UNITED STATES
DEPARTMENT OF THE INTERIOR
BUREAU OF LAND MANAGEMENT
SUNDRY NOTICES AND REPORTS ON WELLS

5. Lease Serial No.	NM0405444-A
6. If Indian, Allottee or Tribe Name	
7. Unit or CA Agreement Name and No	
8. Well Name and No	Todd 22A Federal 1
9. API Well No.	30-015-36828
10. Field and Pool, or Exploratory	Ingle Wells; Delaware
11. County or Parish State	Eddy NM

12. CHECK APPROPRIATE BOX(s) TO INDICATE NATURE OF NOTICE, REPORT, OR OTHER DATA	
TYPE OF SUBMISSION	TYPE OF ACTION
☒ Notice of Intent	☐ Acidize
☐ Subsequent Report	☐ Deepen
☐ Final Abandonment Notice	☐ Alter Casing
	☐ Fracture Treat
	☐ Casing Repair
	☐ New Construction
	☐ Change Plans
	☐ Plug and Abandon
	☐ Convert to Injection
	☐ Plug Back
	☐ Production (Start/Resume)
	☐ Reclamation
	☐ Recomplete
	☐ Temporarily Abandon
	☐ Water Disposal
	☐ Water Shut-Off
	☐ Well Integrity
	☒ Other Rig Layout Change

11" x 5,000 psi BOP Stack

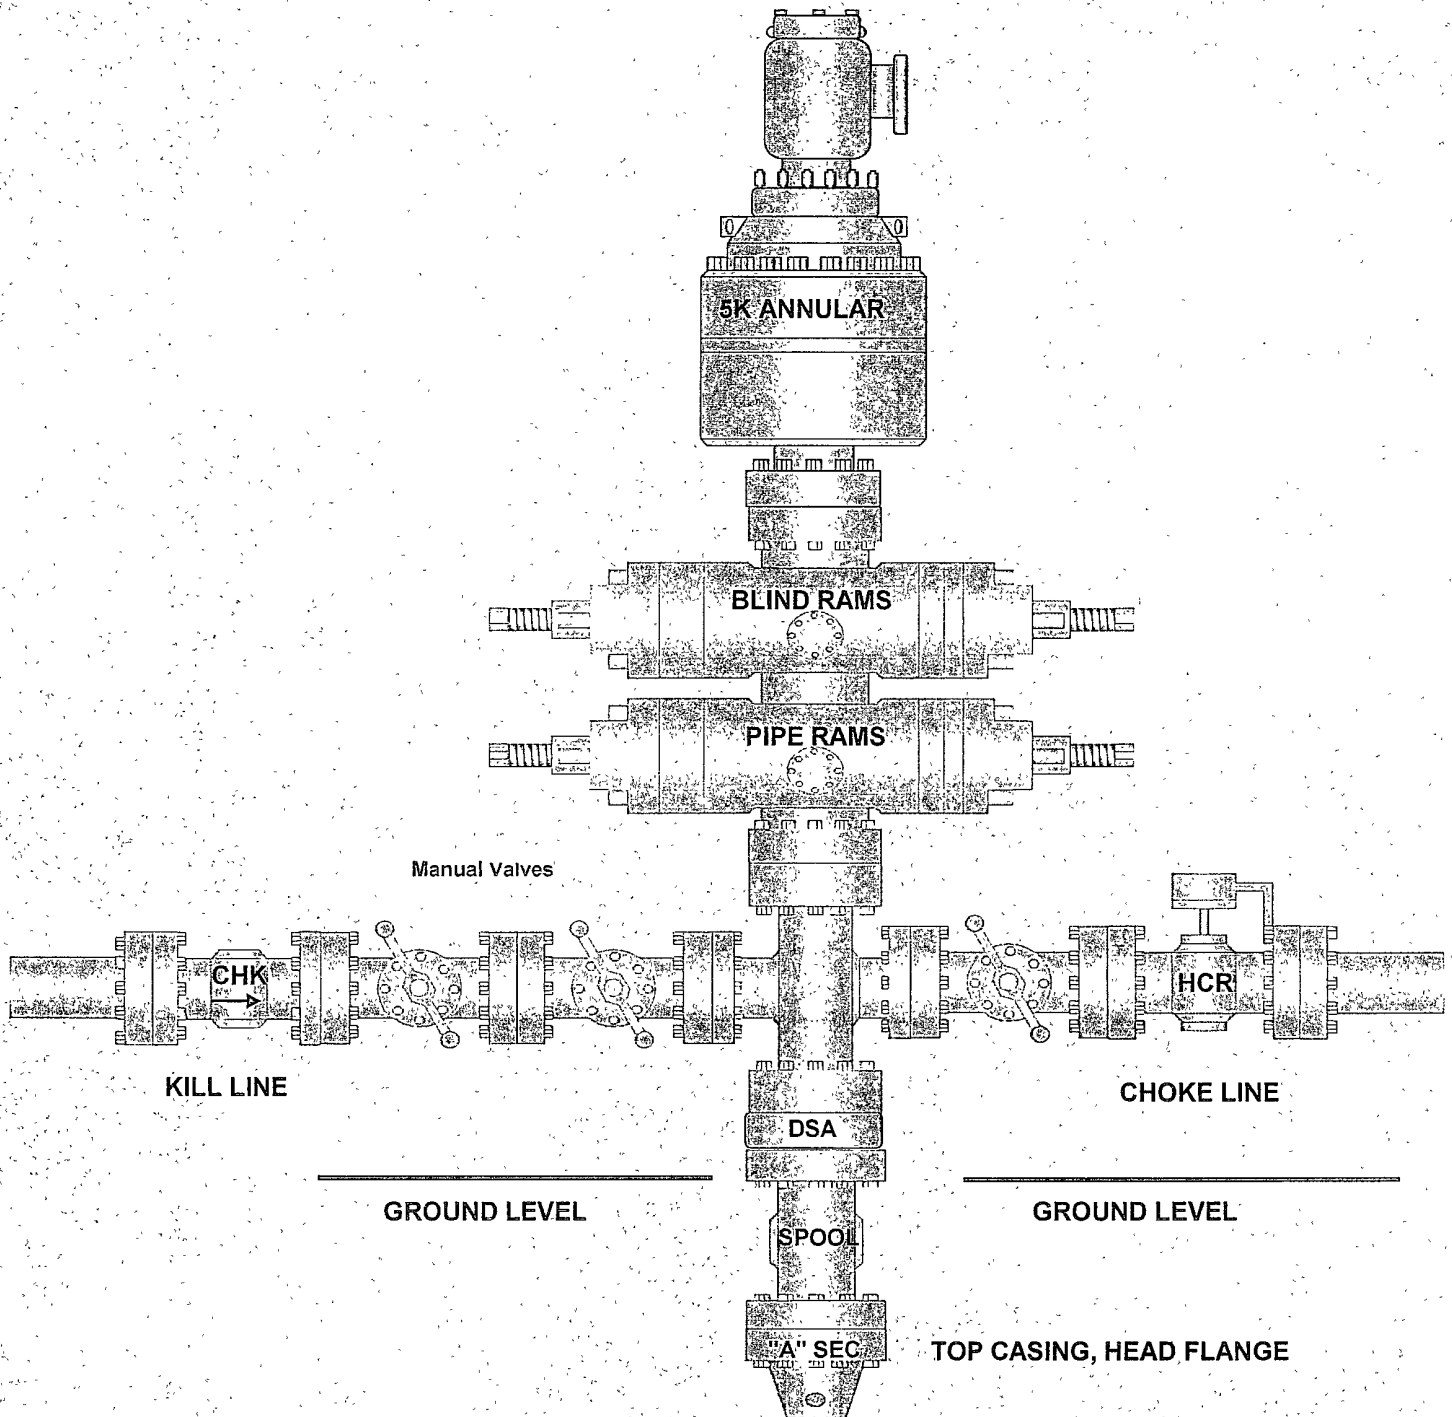
Devon Energy Production Company L. P. respectfully requests permission to change the Rig Layout from Basic Energy Services to Patterson 41. ~~The 13 5/8" 3K Annular nipped up on the surface casing to drill the intermediate hole. Request variance to pressure test with rig pump prior to drilling intermediate hole. The 11" 5K Annular and double rams (pipe & blind) nipped up on the intermediate casing to drill the production hole.~~

Phone call with Mark Cooper - Devon, items not necessary will use O.O.II - 70% on surface casing. ~~MMH~~ 11/25/09
